Re: Summary of 2/19/93 Meeting: Ground-Water Monitoring Issues in
Lower Los Alamos Canyon

Ground-Water Monitoring Of Lower Los Alamos Canyon
Meeting Notes February 19, 1993

ATTACHMENT A

Figure 1. Monitoring well transect locations.

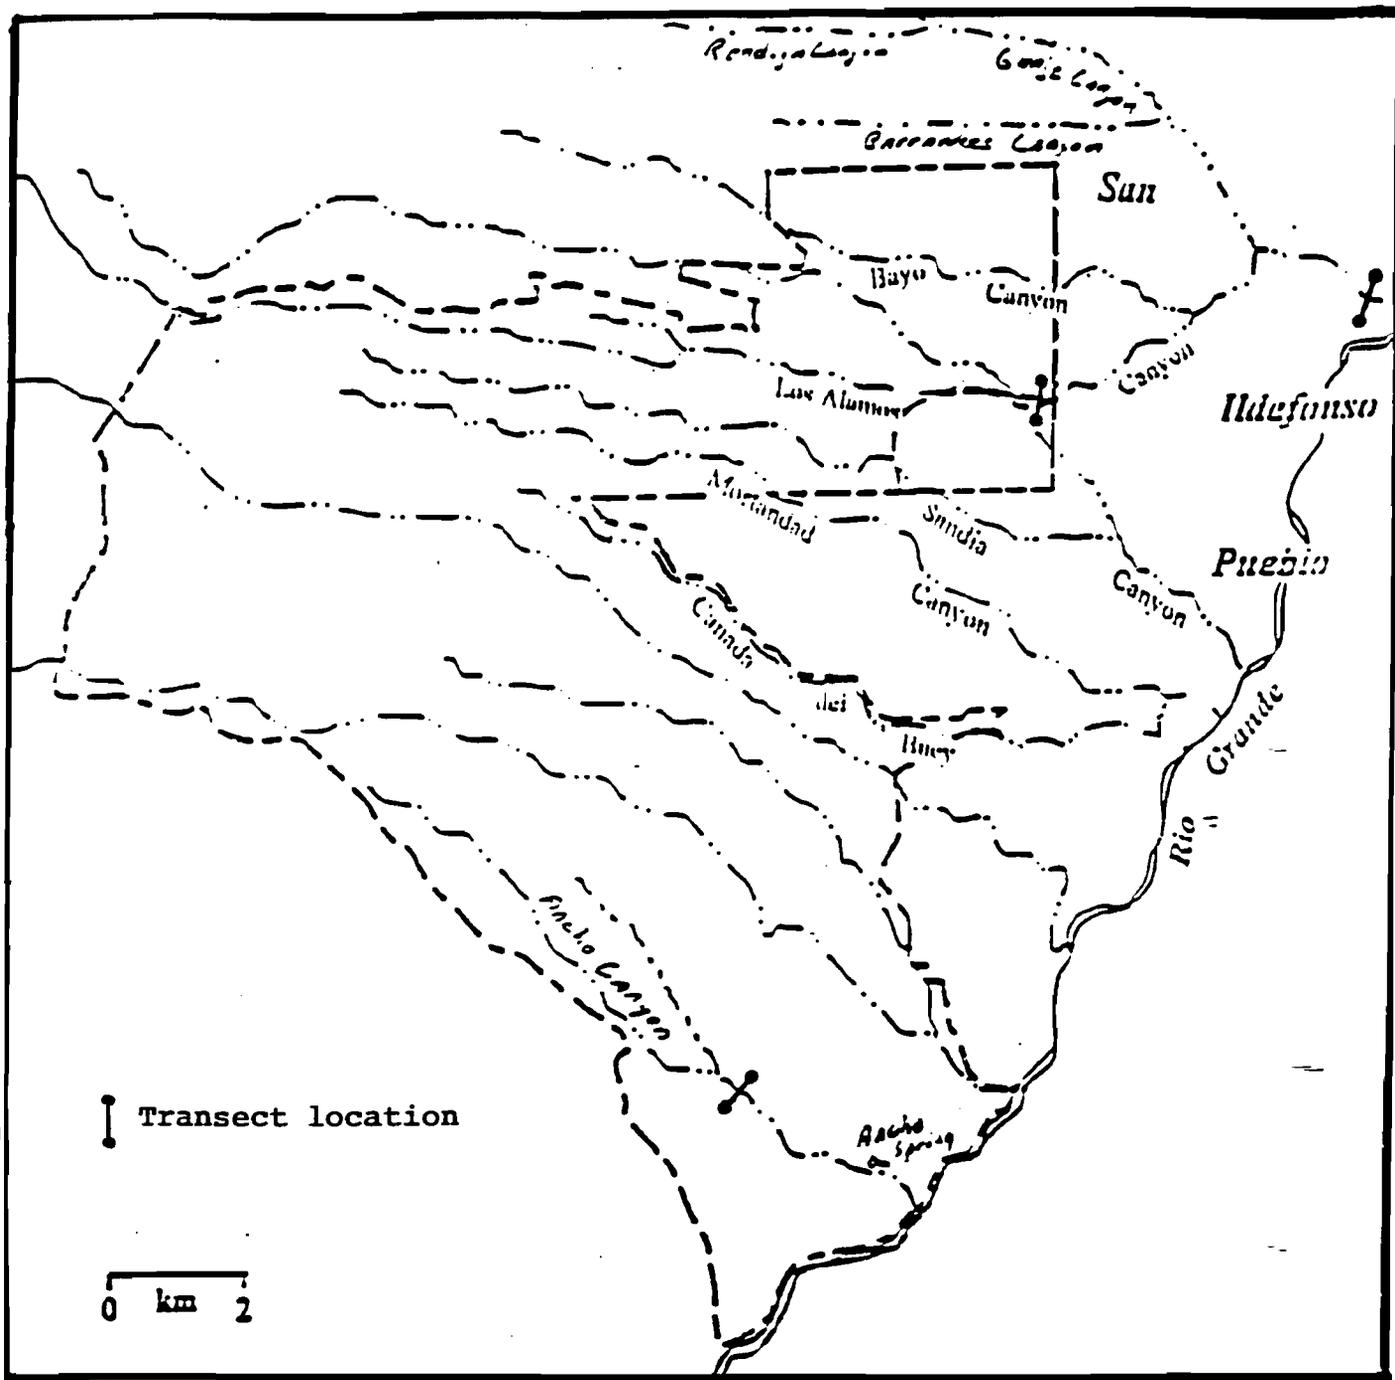
As a result of the 2/19/93 meeting, NMED's AIP staff was requested to specify how it would propose to adequately monitor the perched-alluvial aquifers to ensure that contaminants are not leaving the laboratory boundary. It must be emphasized that these are purely technical recommendations made by Agreement in Principle staff and are not associated with any regulatory components of the Environment Department's Hazardous and Radioactive Materials Bureau. Listed below are recommended locations:

Los Alamos Canyon, downstream of Pueblo-Los Alamos Canyon confluence near Lab boundary (Fig. 1):

Los Alamos Canyon, downstream of Guaje-Los Alamos Canyon confluence (Fig. 1):

Ancho Canyon, downstream of the confluence above Ancho Spring (Fig. 1):

Recommended transects across the perched-alluvial systems are shown in figure 1. It is recommended that at least three wells be installed per transect. Recommended methodology can be found in the Resource Conservation and Recovery Act, Technical Enforcement Guidance Document (TEGD). Paired wells may be necessary if the depth of the aquifer can not be fully monitored within TEGD recommended screen lengths. The ultimate decision for the siting of monitoring wells on San Ildefonso property rests with the Pueblo and access to these wells would be on a Pueblo permission-only basis.

If saturated conditions are not encountered upon completion of one monitoring well in the perched-alluvial aquifer downstream of the Pueblo-Los Alamos Canyon confluence, it is recommended that monitoring wells be drilled into the perched basalt-conglomerate aquifer. Also, it is suggested that three monitoring wells be installed in Ancho Canyon (Fig. 1) contingent upon completion of one monitoring well encountering saturated conditions. If saturated conditions are encountered, two additional wells would be installed transversely across the stream channel.
